# CASE STUDY: EVALUATION OF A TWO-LEVEL RESIDENCE STRUCTURAL PLAN (STILT HOUSE WITH OPEN SPACE ON THE FIRST FLOOR) AND COMPLIANCE RECOMMENDATIONS FOR EARTHQUAKE RESISTANCE IN PUERTO RICO USING ACI318-14 CODE

Author: Moisés Torres Méndez, P.E.  
 Advisor: Manuel Coll Borgo, Ph.D., P.E.  
 Civil and Environmental Engineering and Land Surveying Department  
 Polytechnic University of Puerto Rico

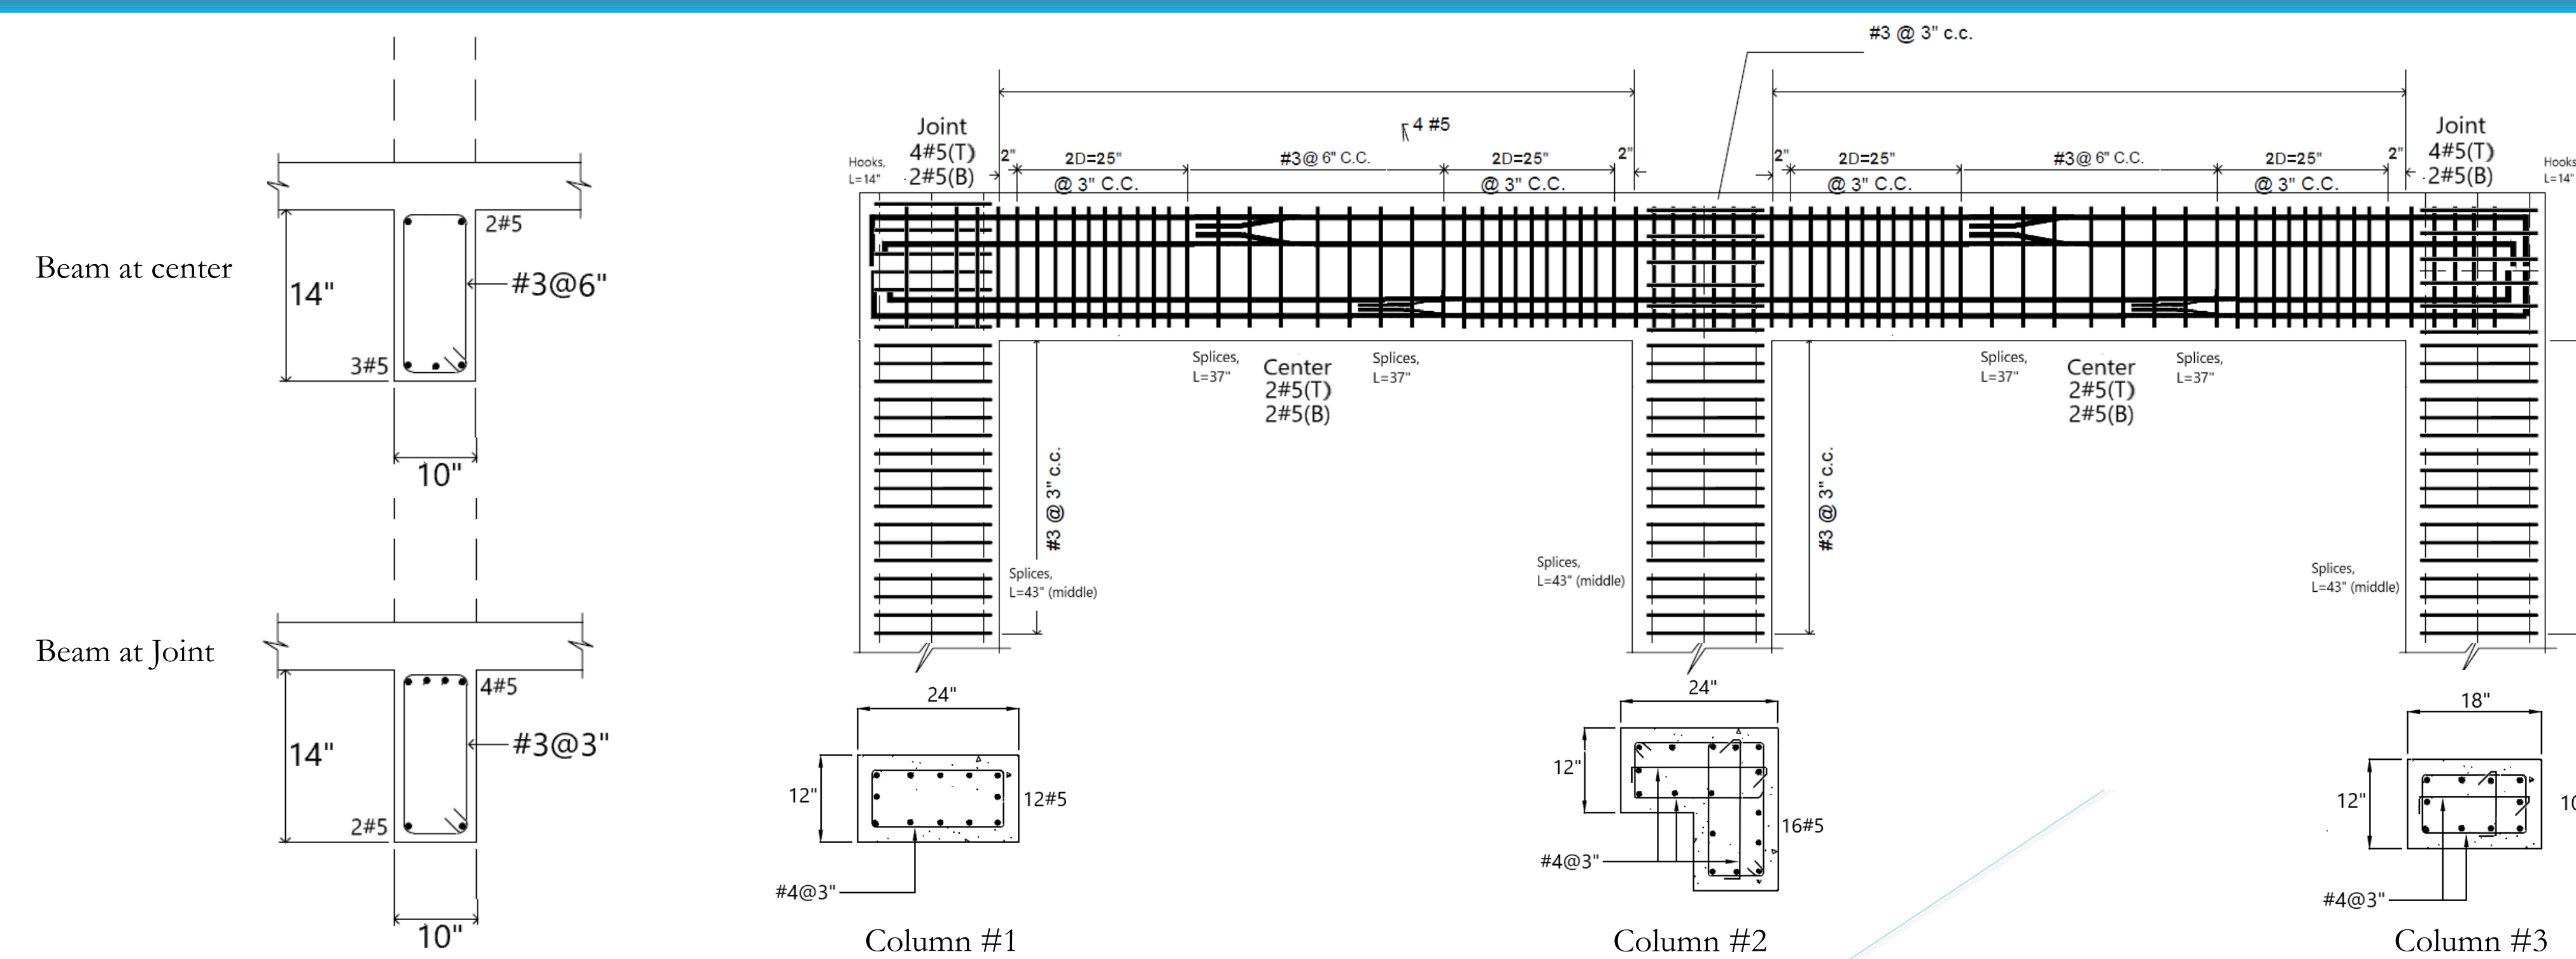
1. This case study's redesign satisfies ACI318-14, 18.2.3 through 18.2.8 and 18.6 through 18.8
2. The original beam (8"x12") was increased to meet the minimum dimensions required in ACI318-14, 18.6.2.1. The final suggested dimension (10"x14") allows a greater effective depth. It is important to ensure from the beginning, that the effective depth,  $d > 14"$ . For a lower height it is necessary to consider the design as a T-beam.

3. The final suggested longitudinal reinforcement in beams is 4#5 top steel (negative moment) and 3#5 bottom steel (positive moment). Joints should have 2#5 bottom steel (50% of negative moment) and center of the beam 2#5 top steel (at least 25% of the maximum moment), ACI318-14, 18.6.3.2.

4. The final suggested transversal reinforcement in beams is #3@2" from the joint, #3@3" for a distance  $2d=25"$  and #3@6" until the center.
5. The bases (widths) of all columns changed from 8" to 12". It is important to ensure that this minimum width is met from the beginning, as established in section ACI318-14, 18.7.2.1.

6. The final suggested longitudinal reinforcement in columns is column #1-12#5, column #2-16#5 and column #3-10#5.
7. The final suggested transversal reinforcement in columns, is column #1-#4@3, columns #2&#3-#4@3" with 1 cross-tie#4 (both directions). First hoop shall be located 2" from the joint ACI318-14, 18.7.5

8. Lap splices of reinforcement are prohibited in beam-column joints. This condition is not allowed, ACI318-14, 18.6.3.3.
9. Final design (from the second run) complies with section ACI318-14, 18.7.3.2, better known as "strong column-weak beam",  $\Sigma M_n/Column > 1.2 \Sigma M_n/Beams$ . About 50% of the original column's sections did not meet this capacity requirement in the first analysis, even on the first floor. The capacity in all elements shall ensure that the beams fail first, so the inertia of the columns is always greater (more rigid). Columns that do not meet this criteria on the top floor (due to no columns coming from the roof's structural slab), should be confined with the minimum tie spacing (in this case study 3") across the entire length of the column. In this case study, all columns have minimum spacing due to 6"DLong.bar, ACI318-14, 18.7.5.5.
